RE: <u>SECTION 73 OF THE TOWN AND COUNTRY PLANNING ACT 1990 TO VARY CONDITION 1</u> <u>ATTACHED TO PLANNING PERMISSION REFERENCE: 3/2021/0010 AT LAND EAST OF</u> CHIPPING LANE, LONGRIDGE

On behalf of our Client, BDW Trading Ltd, we hereby submit an application under Section 73 of the Town and Country Planning Act, to vary Condition 1 (Approved Drawings) attached to planning permission reference 3/2021/0010 at Land East of Chipping Lane, Longridge ('the Site').

The Site forms part of Phases 2 and 3 of the wider scheme known as Bowland Meadow where the majority of the homes are now constructed. However, the built Finished Floor Levels (FFL) of several plots do not align with the FFL shown on drawing no. 459/ED/02 which is listed as an approved drawing under the original Phase 2 and 3 reserved matters consent (ref. 3/2018/0975).

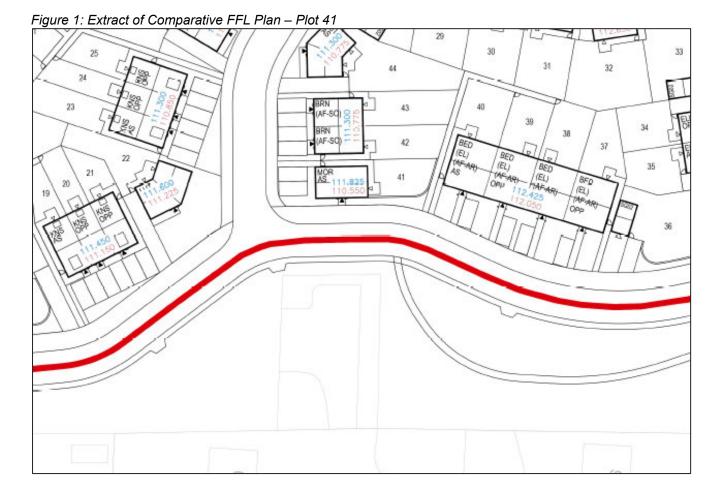
The plots along the southern extents of the Site includes plots 14-22, 36-44, 65-75 and 81-87. The largest difference in FFL amongst these plots is at Plot 41 whereby there is a difference in +1,275mm compared to the approved FFLs.

However, as shown on the Finished Floor Level Comparison Plan (drawing no. 459/ED/166 Rev.C), Plot 41 is orientated on its side and is set back from adjacent properties to the south. This is shown in the extract in **Figure 1** below which demonstrates that plot 41, which has the largest difference in FFL, is not positioned close to existing properties to the south, at approximately 45m away. Therefore, we consider any impact on residential amenity to be negligible in relation to those dwellings which existed before Bowland Meadow was constructed.
